| JRPP No: | 2010NTH034 |
| DA No: | DA10/0801 |

Assessment Report and Recommendation

Development Application DA10/0801 for a Cobaki Estate subdivision of precinct 6 comprised of 441 residential lots (including 1 residual lot) and lots for drainage, open space and urban infrastructure at Lot 1 DP 562222; Lot 2 DP 566529; Lot 1 DP 570077; Lot 1 DP 823679; Lots 46, 54, 55, 199, 200, 201, 202, 205, 206, 209, 228, 305 DP 755740, No. 73 Sandy Lane; Lot 1 DP 570076 Piggabeen Road, Cobaki Lakes

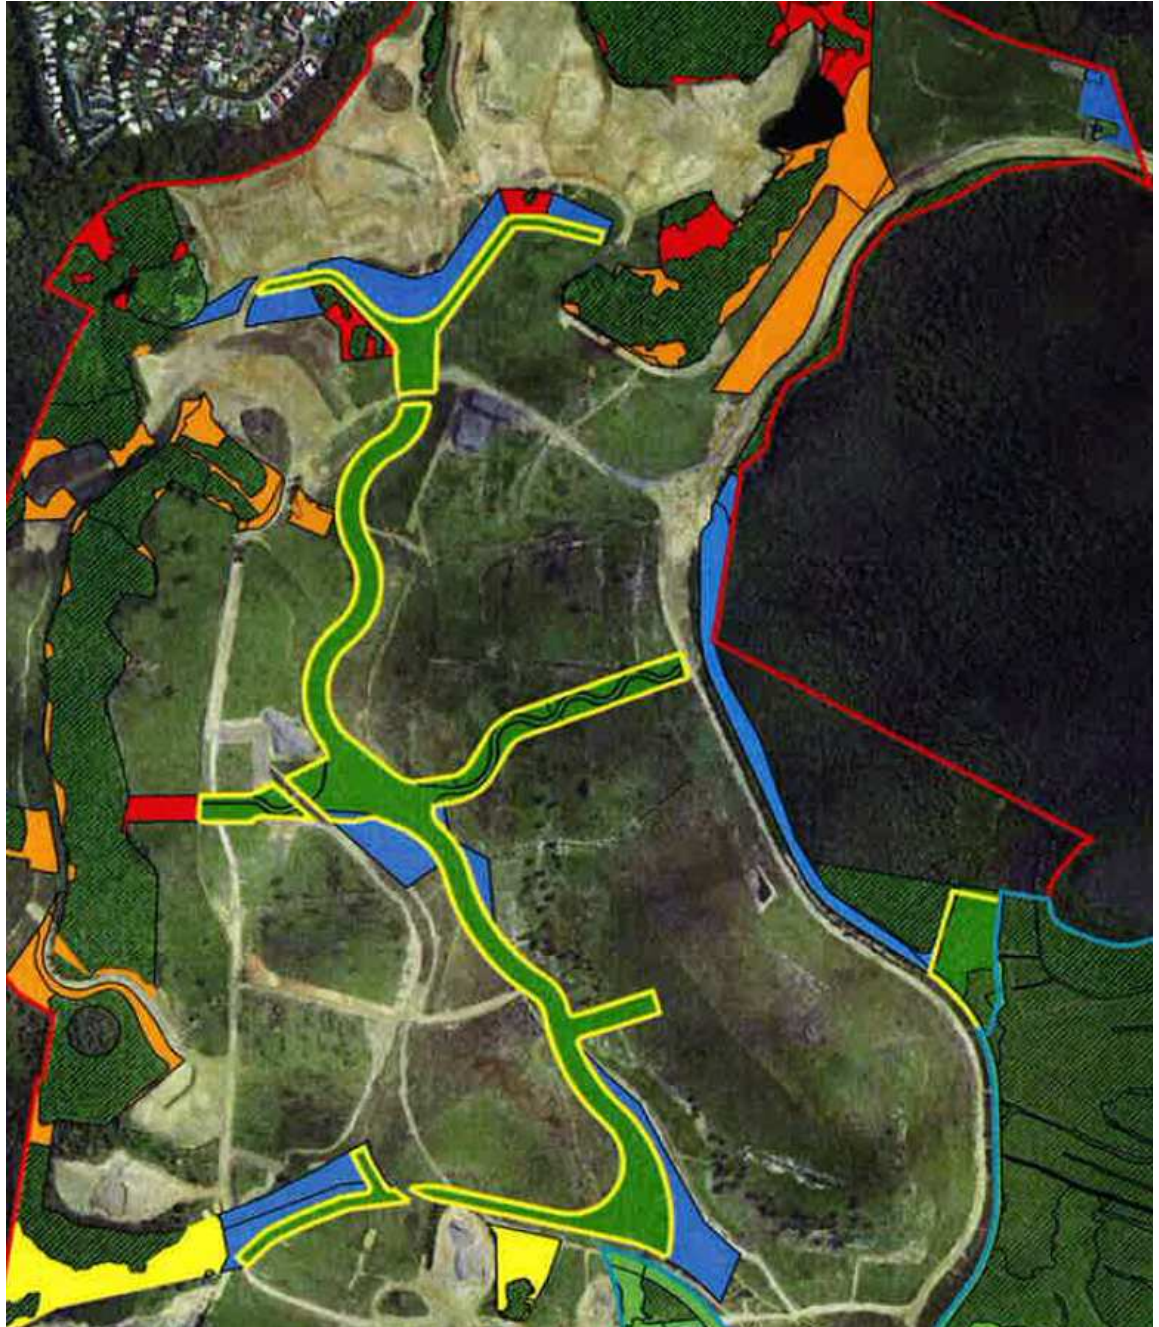
Precinct 6 includes areas between the western perimeter road and the central drainage channel which were nominated and agreed as offsets for the loss of 3.8ha (and the only remaining portion) of Swamp Sclerophyll Forest EEC from the site, all of which will be removed with the Precinct 6 proposal. The concept plan approved the removal of this community subject to the revegetation of a number of discrete parcels, totalling 15.73ha. The areas proposed for offsets were detailed in the *Revised Site Regeneration and*

Revegetation Plan prepared by James Warren and Associates dated October 2010, specifically Figure 5 *Endangered Ecological Community Offset Areas*. This plan formed part of the concept approval at Condition A3 *Project in accordance with documents*. The total offset area is shown as Area 13 on Figure 4 *Rehabilitation and Management Precincts* of this document

The current DA reduces the width and area of two of the proposed parcels, proposes subdivision to remove part of one lot to be encumbered by a sewer pump station and does not provide a management plan or commitment to undertake any such compensatory works prior to the loss of the relevant habitat. This is contrary to the terms of the concept plan and the Statement of Commitments. Because of the effect of Condition A4(2) of the Concept Plan, this conflict within the current DA which will conflict with the concept plan will have no effect as the concept plan will prevail

Because the loss of all remaining Swamp Sclerophyll Forest is proposed to enable the Precinct 6 development, all restoration areas should be detailed and work commenced prior to loss of habitat to ensure that offsets will replace habitat lost.
